# Drainage Letter Report

1830 MAIN STREET  
COLORADO SPRINGS, COLORADO  
80911

December 2, 2019

PPR1938

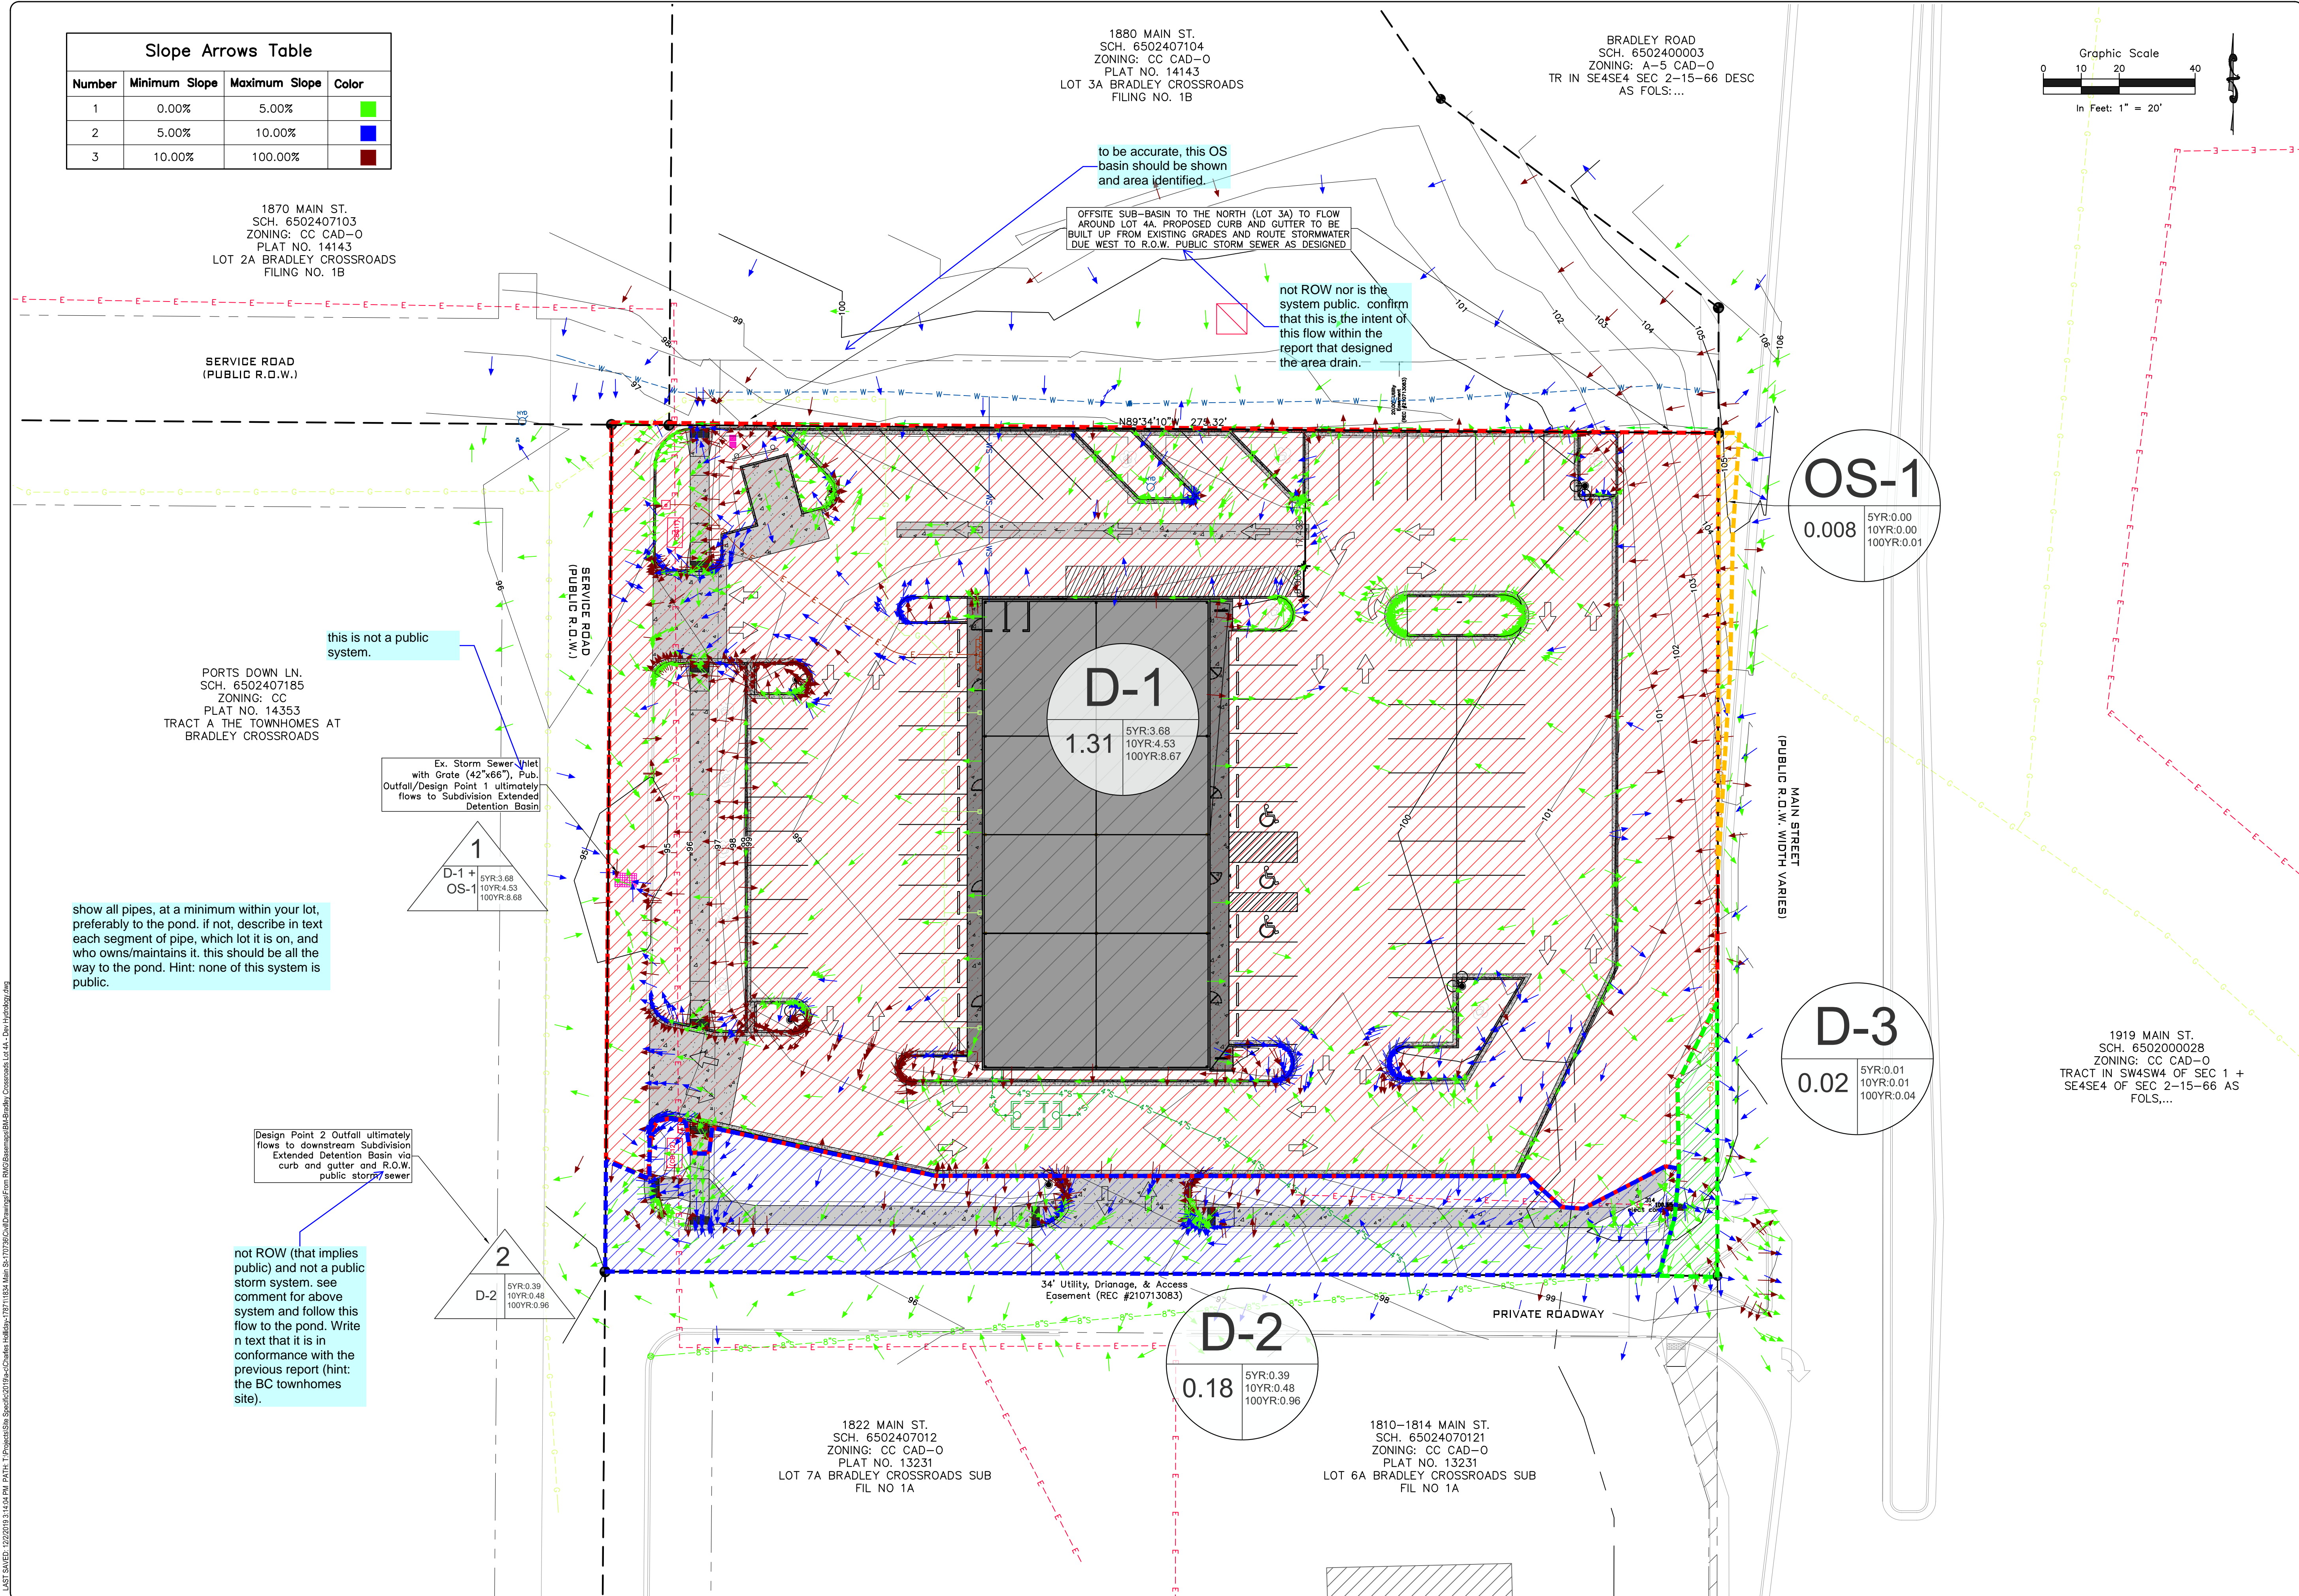
See comments next page, and drawing on last page of this report.
